February 6, 2025

- AGENDA ITEM: Planning File No. MAJ-24-0005: A sketch plan review of multifamily residential development and CU-24-0001, a Conditional Use application to allow for less than 20% mix of uses in the Mixed-Use District located at 200 N 7th Ave
- LOCATION: 200 N 7th Ave / Lot E-2 River Pines Sub Resub Outlot E Replat A River Pines
- ZONING: River Pines Planned Unit Development (PUD) and Mixed-Use (MU)
- APPLICANT: Seth Francis, Blue River Builders
- OWNER: BLUE RIVER REAL ESTATE FUND III LLC C/O Seth Francis PO Box 7035 Breckenridge, CO 80424
- TOWN STAFF:Kris Valdez, AICP, Principal Plannerkrisv@townoffrisco.com(970) 668-9121

<u>Bedrooms</u>

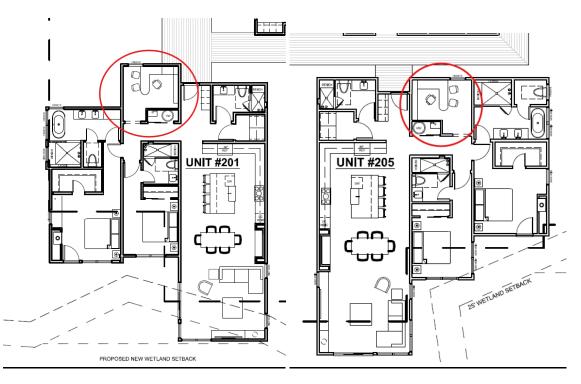
Application materials show office spaces within numerous units. If these are defined as a bedroom, then parking will be required for them. Frisco Town Code, Section 9-3 defines a bedroom as:

Staff find that the proposed office layout in the units meets the definition of a bedroom due to the close access to the bathroom location.

Staff are seeking feedback from the Planning Commission if they are in agreement with this determination.
